To: T10 Technical Committee
From: Rob Elliott, HP (elliott@hp.com)
Date: 31 December 2003
Subject: 04-032r0 SAS-1.1 ALIGNs through expanders

Suggested changes to SAS-1.1 as modified by 03-334r2

Figure 1 — Scenario

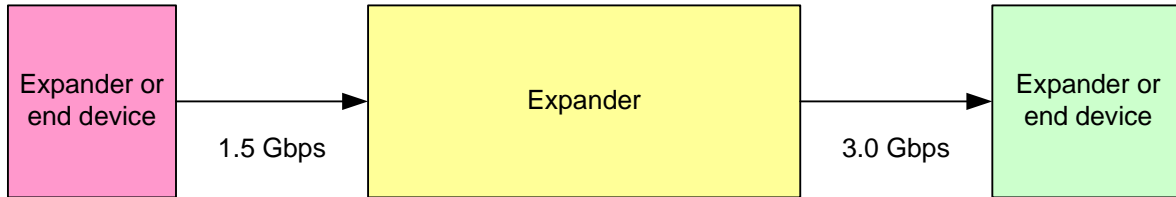
When an expander is forwarding dwords from a 1.5 Gbps link to a 3.0 Gbps link and inserting rate matching ALIGNs, the clock skew management ALIGN frequency requirement of 1 ALIGN every 2048 dwords cannot be met.

As the expander forwards the dword stream, it has to insert rate matching ALIGNs as required on the 3.0 Gbps link - 1 ALIGN every 2 dwords. Essentially, the transmitter underflows a lot. It is not allowed to buffer up N dwords and burst them out together (followed by N ALIGNs) - it is required to dole out the ALIGNs every other dword so the receiver of the data is not required to have any extra buffering.

Figure 2 — ALIGNs on the links

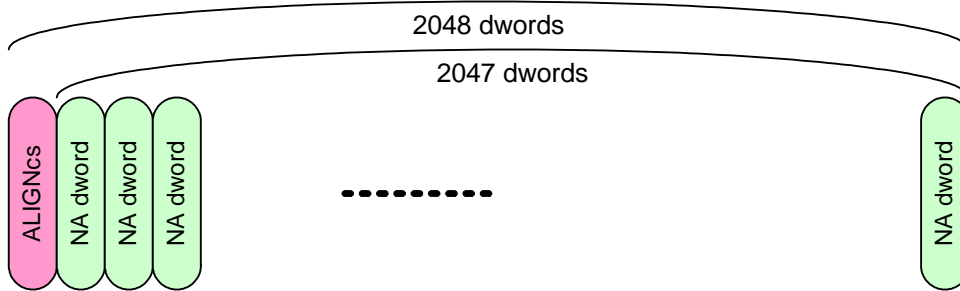
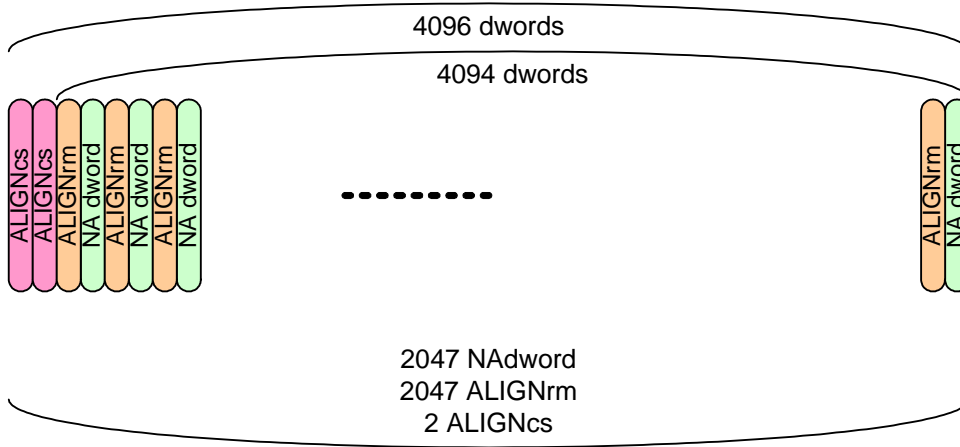
Of the 4094 dwords on the 3.0 Gbps link that are not the two clock skew ALIGNs, 2047 are the non-ALIGN dwords from the 1.5 Gbps link and 2047 are the rate-matching ALIGNs. There are no clock skew ALIGNs in that group - they appeared at the beginning (of the 4096 dword window).

So, on the 3.0 Gbps link, all that can be guaranteed is 2 ALIGNs every 4096 dwords, not 1 ALIGN every 2048 dwords. There are many 2048 dword windows where those ALIGNs do not appear (inside the 4094 dword window). For 6.0 Gbps (in SAS-2), the ratio will grow to 4 ALIGNs every 8192 dwords.

The impact of 2/4096 rather than 1/2048 is that the 3.0 Gbps receiver must have an extra dword buffer in its elasticity buffer. 6.0 Gbps receivers, tolerating 4/8192, will require 3 additional dword buffers total.

Mandating the expander guarantee 1/2048 would require it provide 1028 dwords of buffering (for 3.0 Gbps), which violates the original SAS design goal of expanders to have minimal buffers.

A phy that is the original source for the dword stream (i.e., a phy that is not an expander phy forwarding dwords from another expander phy) shall insert one ALIGN or NOTIFY for clock skew management ~~within every 2 048 dwords (i.e., every overlapping window of 2 048 dwords)~~ [as described in table 1.](#)

Physical link rate	Requirement
1,5 Gbps	One ALIGN or NOTIFY within every 2 048 dwords
3,0 Gbps	Two ALIGNs or NOTIFYs within every 4 096 dwords
